**LEGAL ADVERTISEMENT
PORTLAND PLANNING BOARD MEETING**

- ii. Level III Site Plan and Subdivision; 502 Stevens Avenue; Mixed Use Building; Denis Lachman, Applicant. (5:30 – 6:30 p.m. estimated time) The Board will consider a mixed use building replacing a single family home at 502 Stevens Avenue. The ground floor would have commercial uses and a total of four (4) residential units are proposed on the 2nd and 3rd floors. A shared driveway with parking for 10 vehicles is proposed on the lot. The site is in the B-1b zone.

To: Chair Boepple and Members of the Portland Planning Board

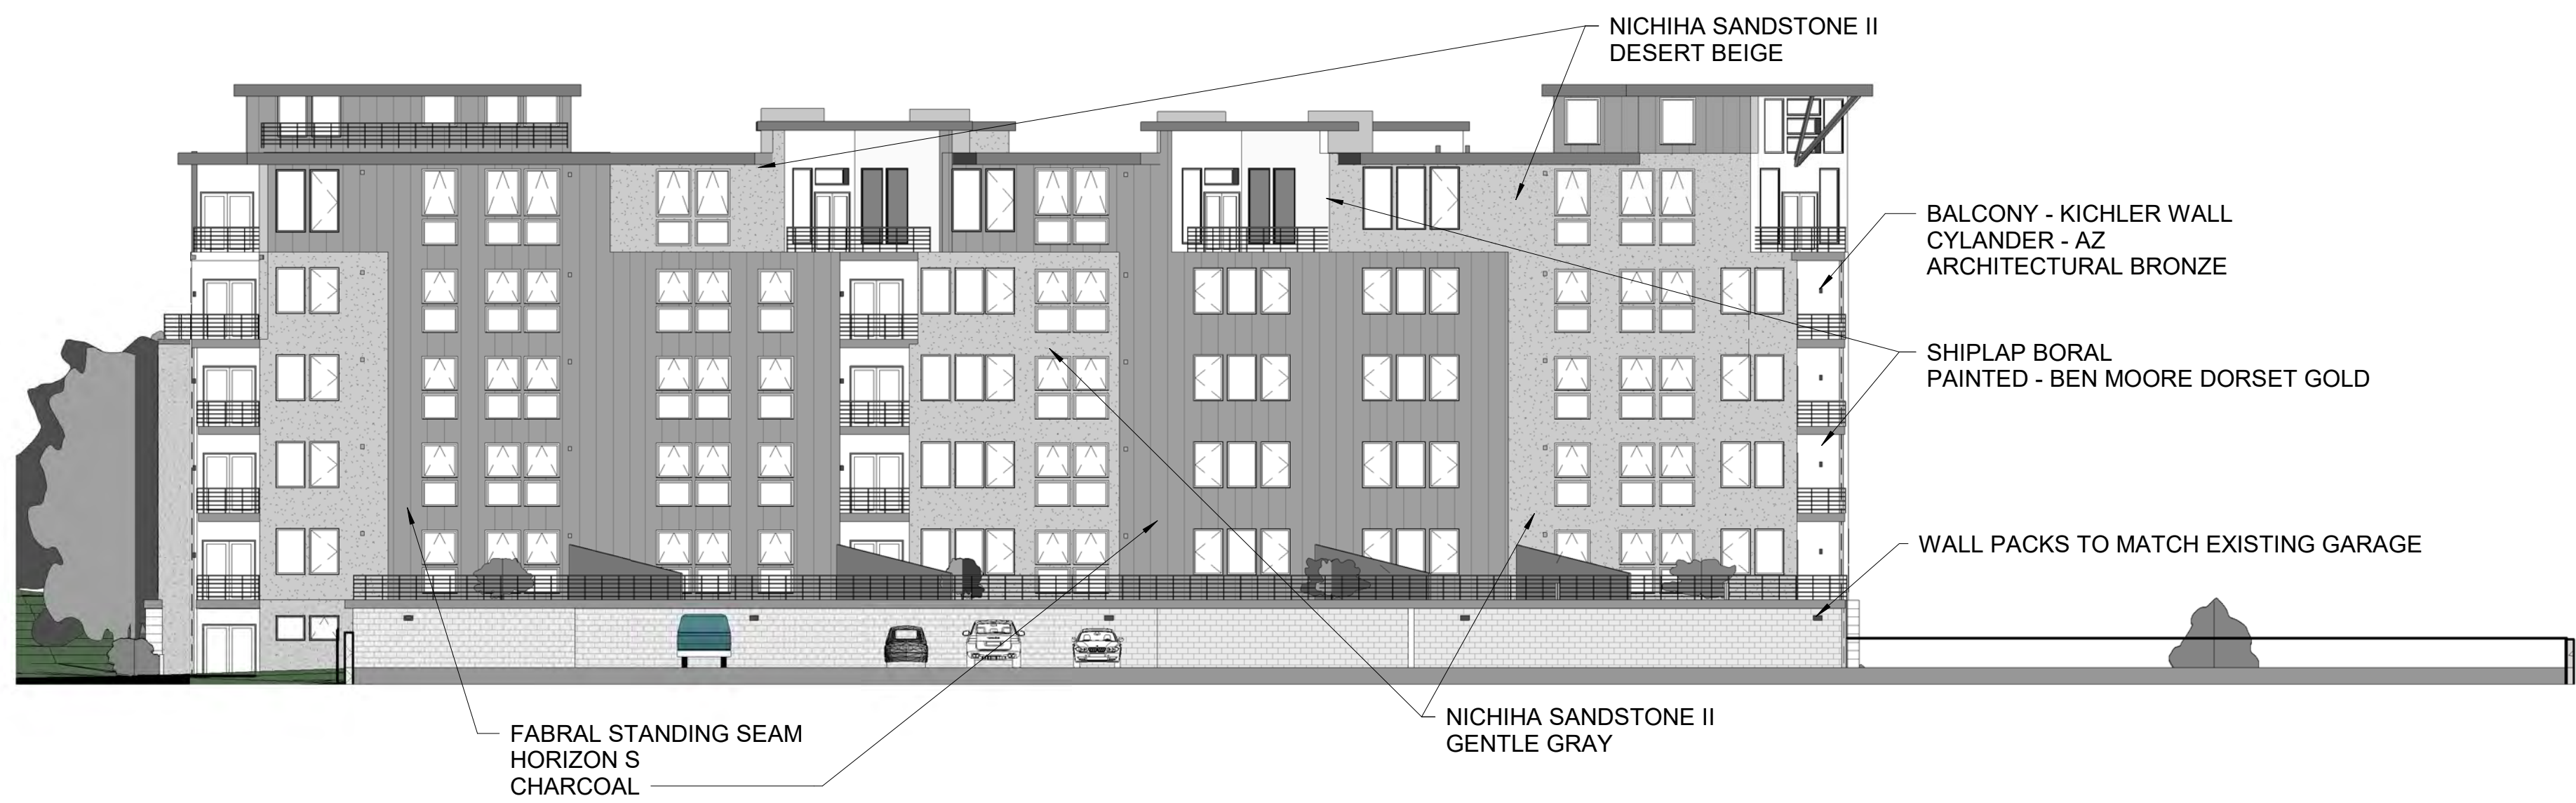
The specific standards that are to be addressed in this revision are with regards to the design at the pedestrian level so that the building provides a sense of scale through articulation and materiality. With these revisions we are requesting a hearing for the final decision on condition 1 of the approval.

1. The projection (projection A) of the building at the entrance to the double height space has been widened to give it more presence on the street. By widening it, more windows can be added to this element allowing for symmetry and creating a feeling of a more complete element.

2. A second projection (Projection B) in the façade has been added where previously the design was only differentiated by material. This projection begins at the second level and continues through the 6th floor and projects 3'-6". By extending the building out over the ground level, this allows for the placement of columns to help denote the entry/communal portion of the building for the tenants and create exterior enclosure prior to entering the lobby. Again, symmetry of windows is used to complete the element.
